DE8-05 – Design Exception – Shared Driveway Standards – On-Site Parking
Camelot Gardens

DESIGN EXCEPTION #DE 8-05

**Re: Request for TEDS Exemption for Shared Driveway Standards
Camelot Gardens II
2843 Elm Avenue**

CAMELOT GARDENS II
PRELIMINARY PLAN
2845 ELM AVENUE

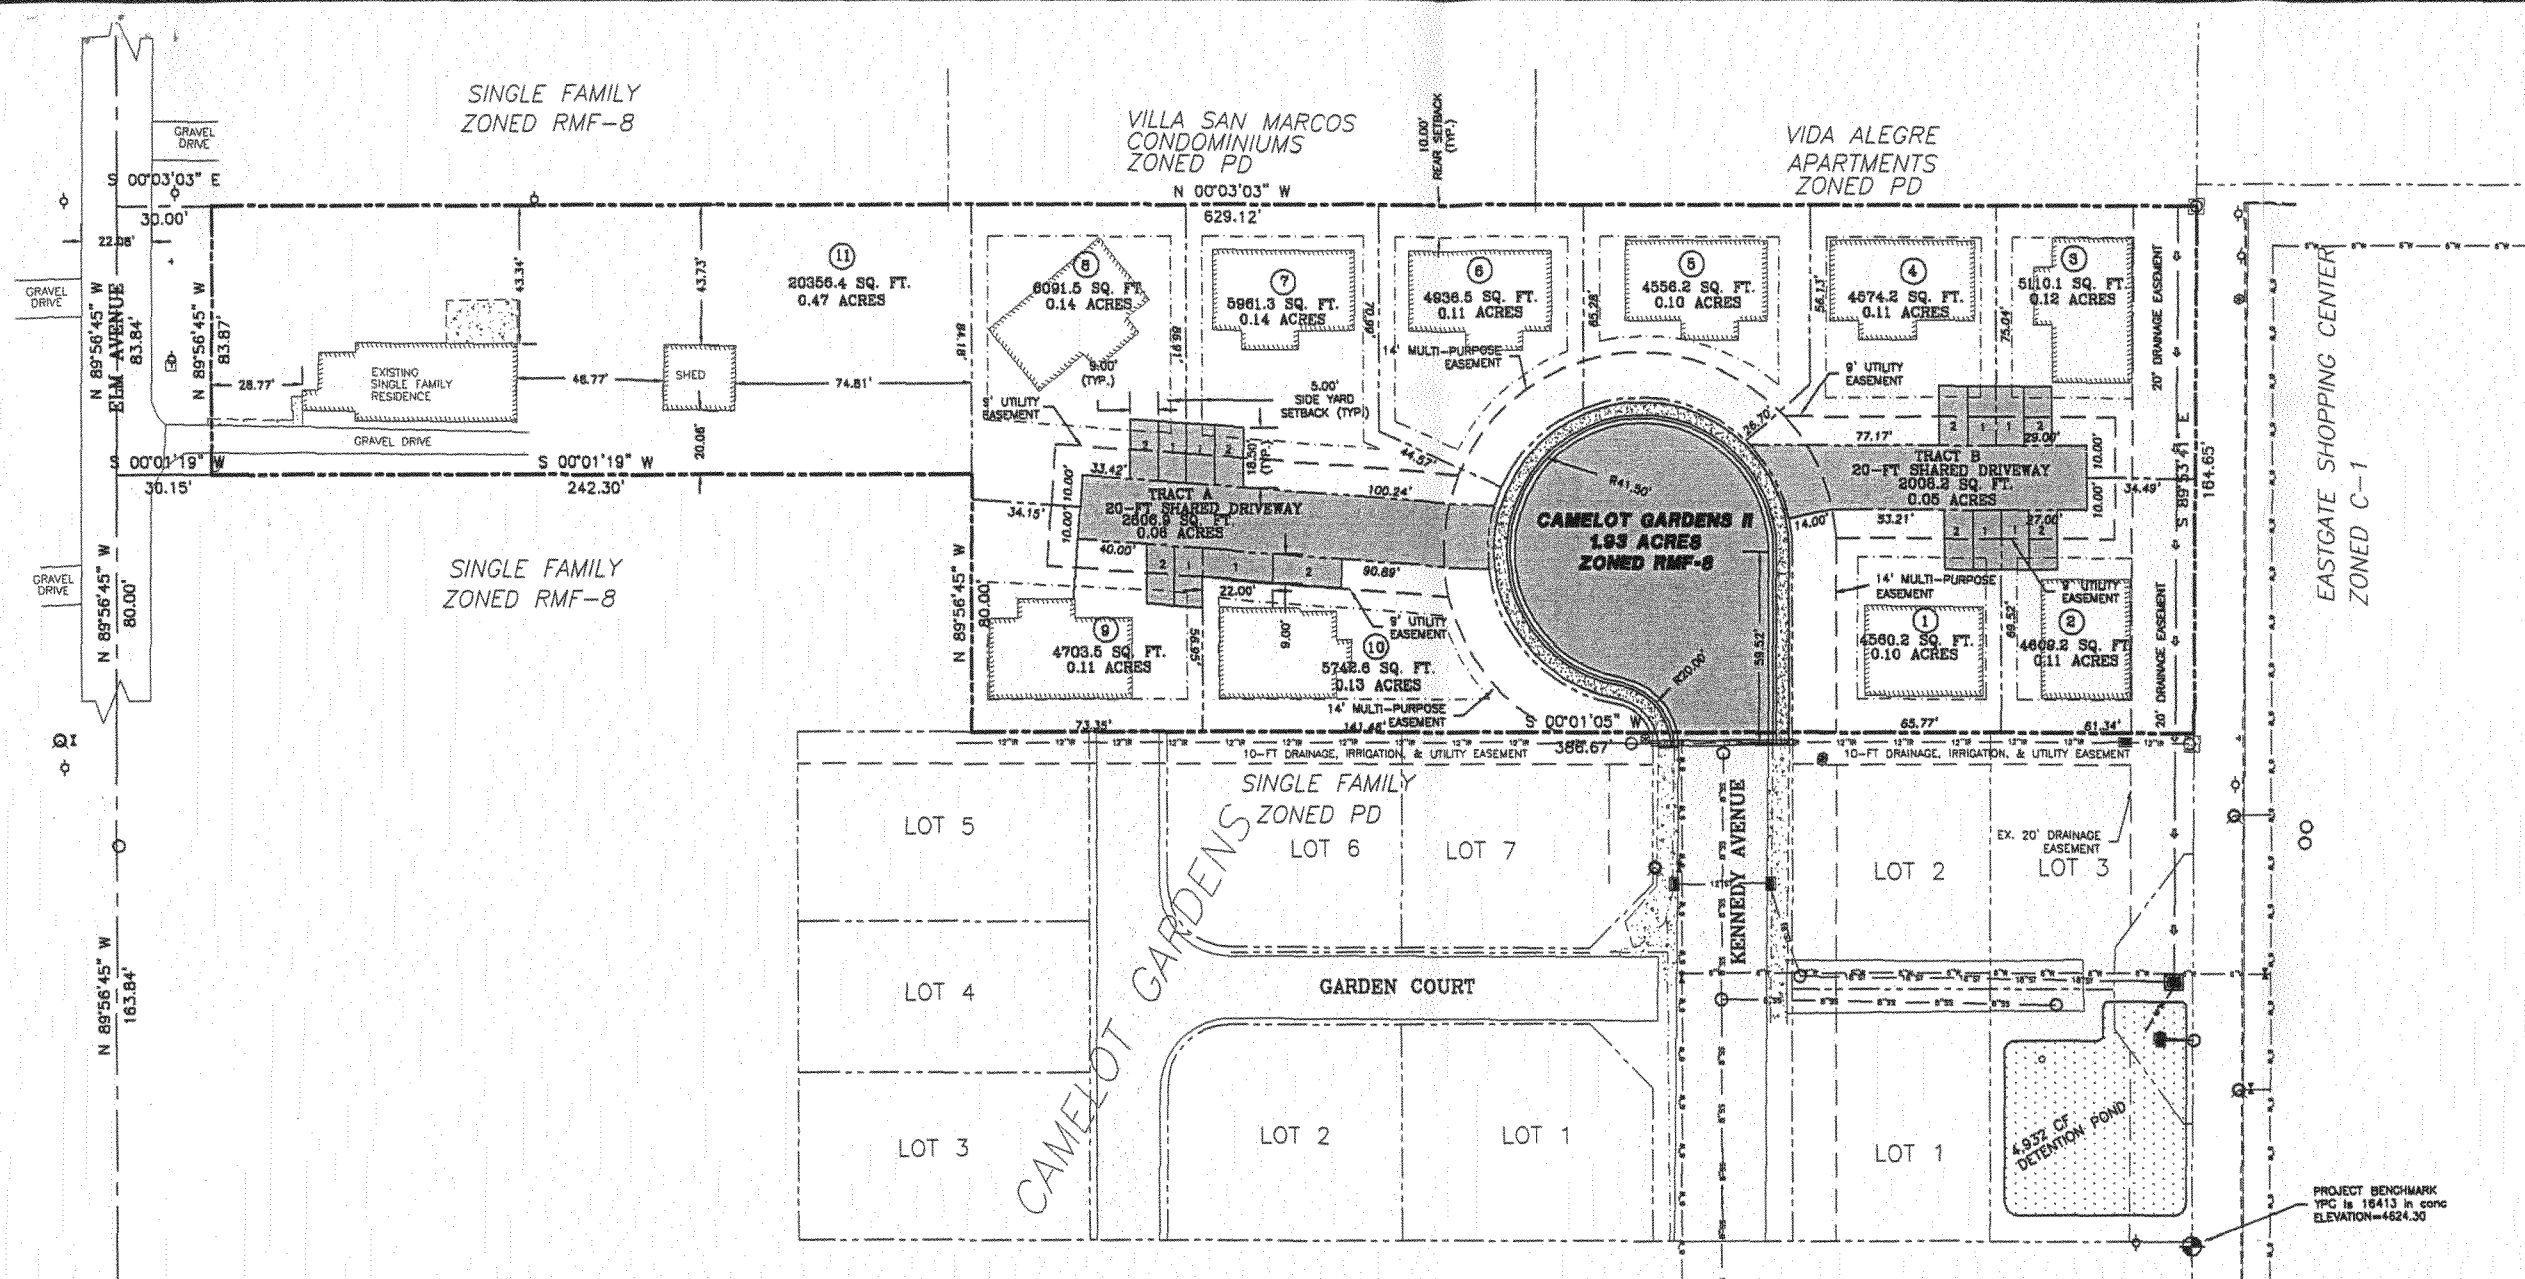
They don't have the income to afford five vehicles, which is the requirement stated in TEDS. We ask that this requirement be lowered to 2 vehicles per household, which is more realistic as a result of the income associated with individuals that reside in such units. Residents can then use the 9' Parking Easement for parking and utilize more of their lot for landscaping, etc.

I have included an exhibit that depicts the proposed "Preliminary Plan" layout requested by this exemption. If you have any additional questions or concerns, please give me a call at 242-7540.

Because staff is not aware of other projects utilizing this design, a comparison of the appropriateness of the request is difficult. Staff has observed several cars present in Camelot Gardens Phase, adjacent to the proposed project, but these observations did not provide conclusive evidence of the number of vehicles owned by similar occupants. Absent data to confirm the appropriateness of the request, staff would recommend denial of the request.

Denied
